Pace Bus Depot Location Analysis

Additional notes from Working Group members:

Parkview Lot - Planning-Level Budget \$3.0 – 5.0 Million

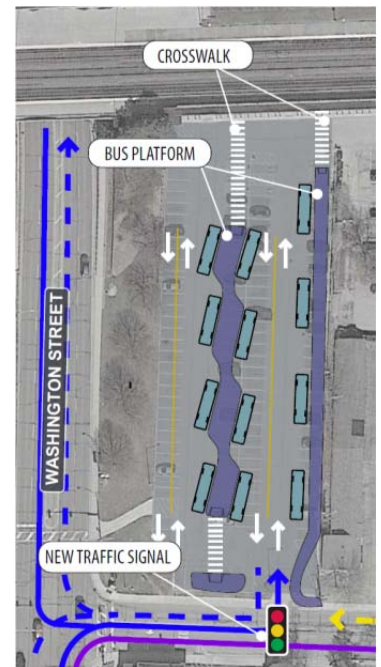
A bus depot should be open air and not understructure. Idling buses affect immediate air quality and the vision of a dark dingy low ceiling height terminal doesn't fit within the context of the surrounding neighborhood which may attract vagrants.

Capacity will be constrained by the size of the space, once adopted. Space will be hard to repurpose if needs change. Closed space may be less pleasant for commuters if it is dark and dirty. Idling buses will make air quality a problem, and may make it impossible to maintain a clean welcoming space. Closed, sheltered space will almost certainly attract loiterers and vagrants, which will detract from the commuter experience and be a safety risk for the neighborhood.

An at-grade bus depot with a building above would require ventilation designed accordingly, in consideration of air quality for bus passengers as well as users in the building above. Aesthetic concerns of a dark and low-ceiling height terminal can be addressed with lighting and increased ceiling heights, respectively.

An at-grade bus depot with a building above may be harder to repurpose. If implemented, the concept could take into consideration findings from the Parking Working Group regarding the repurposing of parking garages. If at-grade (with building above), the depot could be an open-air concept without walls, however, mechanical ventilation may still be required. Aesthetic concerns of a dark and low-ceiling height terminal can be addressed with lighting and increased ceiling heights, respectively.

DuPage Children’s Museum – Planning-Level Budget \$4.0 – 6.0 Million

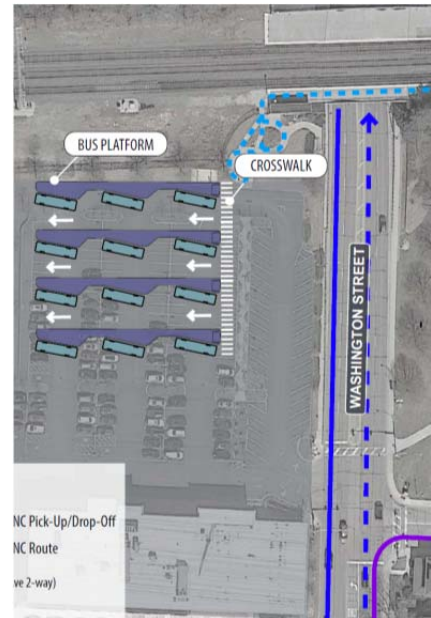
It doesn't necessarily separate buses from cars, if the museum lot is used either as a commuter or retail/office parking garage.

Arguably, kiss-n-ride should be on the museum parking lot, with bus depot at the station. This would get the greater majority of people (bus riders) dropped as close as possible to the station, and reduce the vertical integration problems. Meanwhile, a little extra car traffic on the museum lot would not be the same type of traffic problem as would be for buses mixed with parking traffic.

Note that this [a bus depot on the museum lot] would not be as great a concern if kiss-n-ride was placed on the museum lot, because the north side drop off is likely to be close to the tracks and more accessible to ADA compliant ramps under the tracks. Kiss-n-riders can choose where to make the drop. Bus riders are stuck with wherever the bus drops them.

Correct; the lot could have other commuter or private land uses. This could result in buses and cars sharing internal circulation routes.

Kiss-n-ride could be implemented on the museum lot with development above. Traffic should be considered given the higher volume of kiss-n-ride vehicles compared to Pace buses. Intersection function of North/Spring/Washington will be important. It is reasonable to assume that some commuters may use the museum lot today for pick up and drop off, particularly if coming from west of Washington St.

Placing a bus depot on the museum lot does result in a longer ADA route than current conditions, particularly when the Ellsworth tunnel must be used. A proposed Core Functional Component is to maintain kiss-n-ride facilities on both sides of the tracks. Doing so would allow kiss-n-ride users to avoid the Ellsworth tunnel or other pedestrian rail crossings.

4th Avenue - Planning-Level Budget \$300,000 – 500,000

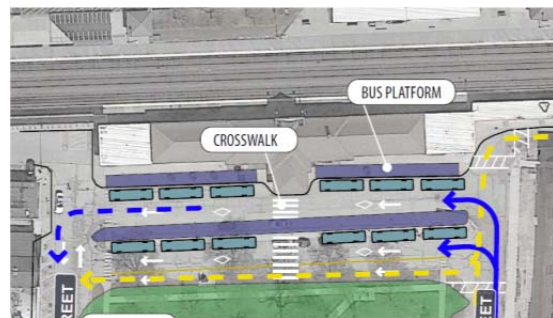
Northbound traffic will not be able to access 4th Ave when the gates are down, so drivers may chose to instead not use a formal kiss and ride designated drop off area.

Dumping 4th Ave traffic into the Burlington Square area does not truly separate kiss-n-ride traffic from bus traffic. It also leaves room for kiss-n-ride people to drop off in front of the station, which they will do if they see open space.

This is a serious detriment to the neighbors, regardless whether they are owner-occupied or rentals. 4th Ave is narrow even for a one-way street. Cars pulling in and out of drop-off stalls parallel to the flow of traffic would be a significant problem. Back-ups at the airports are severe, even with more space and extra lanes to work with.

4th Ave will be inaccessible if traffic backs up on Loomis while the RR crossing gates are down.

If 4th Avenue is converted to a westbound one-way street, kiss-n-ride users driving north would turn left onto 4th Avenue from Loomis. If traffic on Loomis was blocked by a train with gates down, users may not be able to make the turn onto 4th Avenue. As one potential solution, the City could consider adding a northbound left turn lane at this location.

Westbound 4th Avenue traffic would exit south on Ellsworth, while Pace buses would travel north on Ellsworth. This would create a condition where Pace buses must turn left into the loading berths across kiss-n-ride departing traffic. Regardless of bus depot location, enforcement may be needed to prevent kiss-n-ride users from stopping in designated bus lanes.

This improvement was suggested in the 2012 bus depot study, which noted “While buses would not queue on neighborhood streets, kiss-and-ride activity would be relocated to 4th Avenue between Ellsworth Street and Loomis Street. Feedback with neighbors along 4th Avenue indicated opposition to this kiss-and-ride staging concept.” 4th Avenue is approximately 20’ wide; should a vehicle stop to parallel park, it would block traffic until fully parked.

If 4th Avenue is converted to a westbound one-way street, kiss-n-ride users driving north would turn left onto 4th Avenue from Loomis. If traffic on Loomis was blocked by a train with gates down, users may not be able to make the turn onto 4th Avenue. As one potential solution, the City could consider adding a northbound left turn lane at this location.

Burlington Square - Planning-Level Budget \$500,000 – 1.2 Million

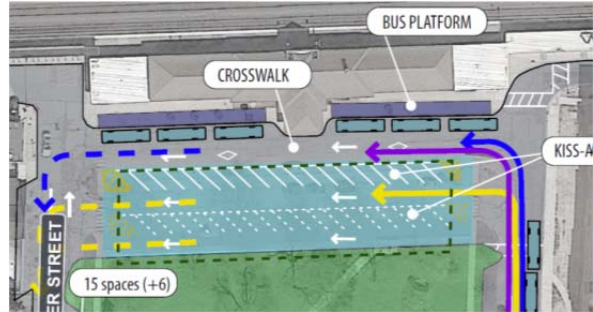
The differences between the 4th Ave and the two Burlington Square concepts is only in the location of the kiss-n-ride. We should consider all options for kiss-n-ride, independent of the location of the bus depot. The parkview lot and the museum lot both could serve as spots for kiss-n-ride. Either would more effectively segregate cars from buses, and would leave the space in front of the station dedicated for bus traffic.

Diagonal stalls would greatly improve capacity and experience for drop-offs and pick-ups. This would also encourage kiss-n-ride drivers to be in the right place and leave the bus platform for the buses.

They [Pace & kiss-n-ride vehicles] would be separated where they park, which currently seems to be the place of greatest contention.

This is a very attractive idea, and one that would substantially improve the neighborhood experience at minimal relative cost.

The kiss-n-ride could be located independently of the bus depot on the Parkview or Museum lots with development above. Similar to the Pace bus depot, final traffic patterns and geometries should be considered when reviewing these options.

Diagonal stalls could help prevent loading/unloading vehicles from blocking lanes of traffic, when compared to parallel stalls. Additionally, Uber and Lyft vehicles are identified by their license plates. Facing vehicles towards the station may help riders locate their designated vehicle.

This concept intends to limit the use of bus lanes by kiss-n-ride vehicles. However, enforcement may be needed to prevent kiss-n-ride users from stopping in designated bus lanes.

Given the limited off-peak hour uses of the bus depot and kiss-n-ride facilities, it is important to investigate multi-purpose uses of these neighborhood areas.

Burlington Square Alternate - Planning-Level Budget \$500,000 – 1.2 Million

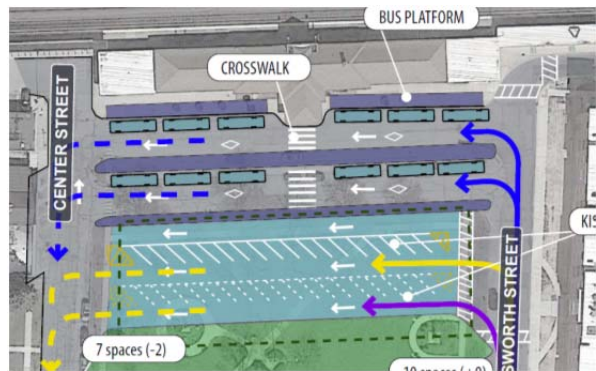
They [Pace & kiss-n-ride vehicles] would be separated where they park, which currently seems to be the place of greatest contention.

Could encroachment be limited by using only a single row of diagonal stalls? In terms of capacity, would that improve on today's configuration? Instead of pull-through stalls, could pull-in, back-out configuration be used?

Input or study on the use of Burlington Square Park might be helpful. This is one of very few green spaces within the neighborhood south of the tracks and east of Washington. But, knowing how the space is used might make it easier to assess whether taking some space from the park would be a detriment to the neighborhood.

This is a very attractive idea, and one that would substantially improve the neighborhood experience at minimal relative cost.

This concept intends to limit the use of bus lanes by kiss-n-ride vehicles. However, enforcement may be needed to prevent kiss-n-ride users from stopping in designated bus lanes.

This concept provides approximately 19 diagonal stalls with a single row, and 38 with two rows of diagonal stalls. Currently there are 11 designated parallel parking stalls for kiss-n-ride functions.

Any impacts to Burlington Square Park for transportation improvements would need to be reviewed and approved by the City and Park District.

Given the limited off-peak hour uses of the bus depot and kiss-n-ride facilities, it is important to investigate multi-purpose uses of these neighborhood areas.
